**DUKE POWER**

Subject: Catawba Nuclear Station, Units 1 and 2  
Docket Nos. 50-413 and 50-414  
Proposed Technical Specifications (TS) Changes  
(TS 3/4.4.8 and Table 4.4-4)  
Determination of Reactor Coolant System Specific Activity

**ATTACHMENT 1**

**BACKGROUND AND DESCRIPTION OF AMENDMENT REQUEST**

Figure 1 - Rheodyne Model 7010 Six-Port Rotary Valve

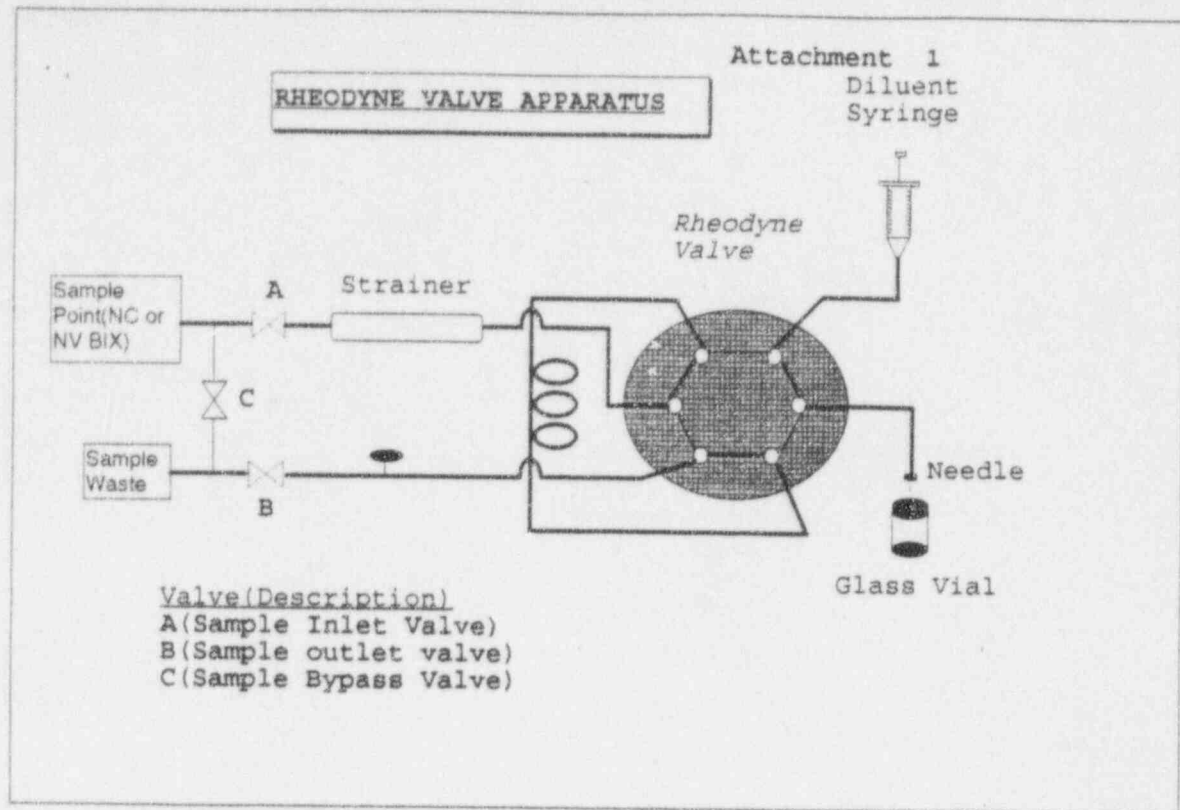
An alternative sampling method, known as the pressurized dilution method of NC sampling, has been statistically validated. This method involves the use of technology such as the Rheodyne Model 7010 six-port rotary valve for pressurized sample collection. This valve was adapted from liquid chromatography (LC), where it is widely used because of its high volumetric precision. The Model 7010 valve (see Figure 1) can be equipped with 5.0-microliter to 5.0-milliliter sample loops and has a maximum temperature and pressure rating of 150 degrees C and 5000 psi, respectively.

With the pressurized dilution method, a known volume of NC system water is trapped and then injected into a 14-milliliter gas sample vial by flushing with a known volume of dilution water. This diluted sample, which contains both gaseous and dissolved nuclides, can then be counted on a gamma spectroscopy detector and used in quantification of total specific activity. A NC sample can be obtained in fifteen minutes by the pressurized dilution method, thereby resulting in a 75% decrease in time of sampling and radiation exposure for plant Chemistry personnel. Counting instrument geometries, isotopic libraries, and programming have been upgraded to permit the use of the pressurized dilution sampling technique.

TS Table 4.4-4 Table Notation \*\* is modified to read: "... The total specific activity shall be the sum of the beta-gamma activity in the sample within 2 hours after the sample is taken and extrapolated back to when the sample was taken. ..."
